IMPROVEMENTS TO THE SUPPORT KIT AND PROFILE FOR AIR CONDITIONER 550

IMPROVEMENTS TO THE SUPPORT KIT AND PROFILE FOR AIR CONDITIONERS 420 AND 460

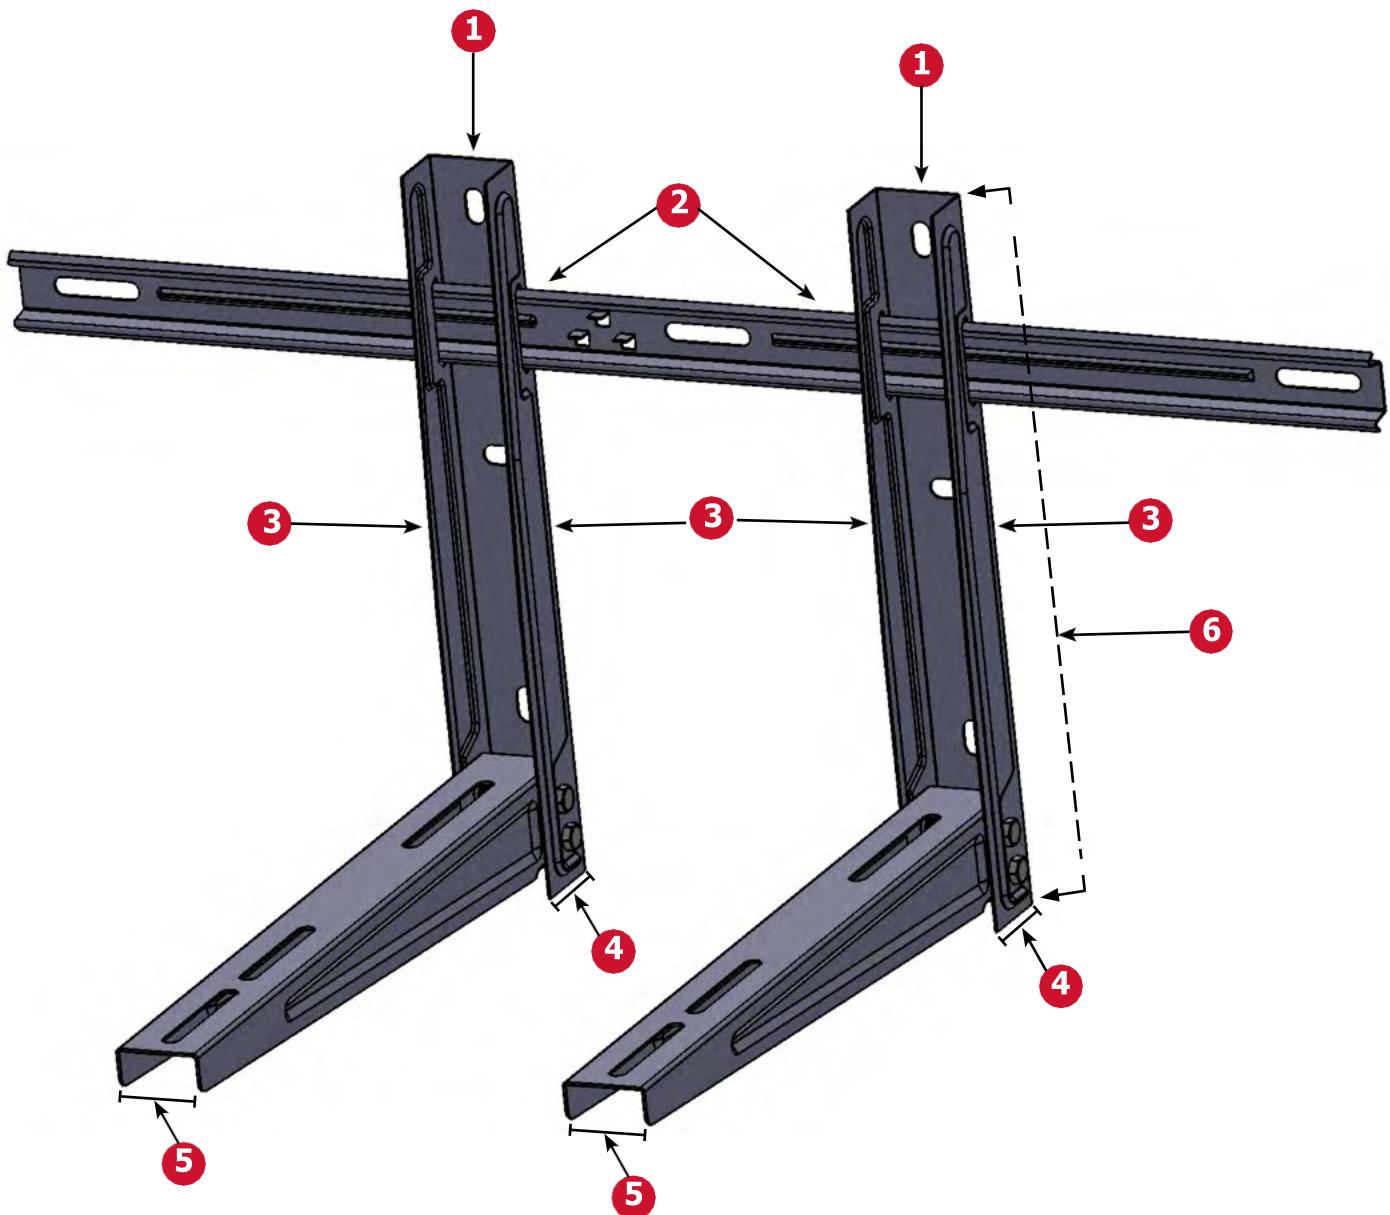
- 1 Hole on the top part for better bracket fixation
- 2 Longitudinal reinforcement ribs in the adjustment bar
- 3 Reinforcement ribs on the sides of the bracket
- 4 Larger size for better reinforcement
- 5 Wider base (45 mm)
- 6 Longer vertical part of the bracket (400 mm)
- 7 Additional holes 80x10.5 for better adjustment

Note: larger universal wall plugs, Ref No: 2411200000
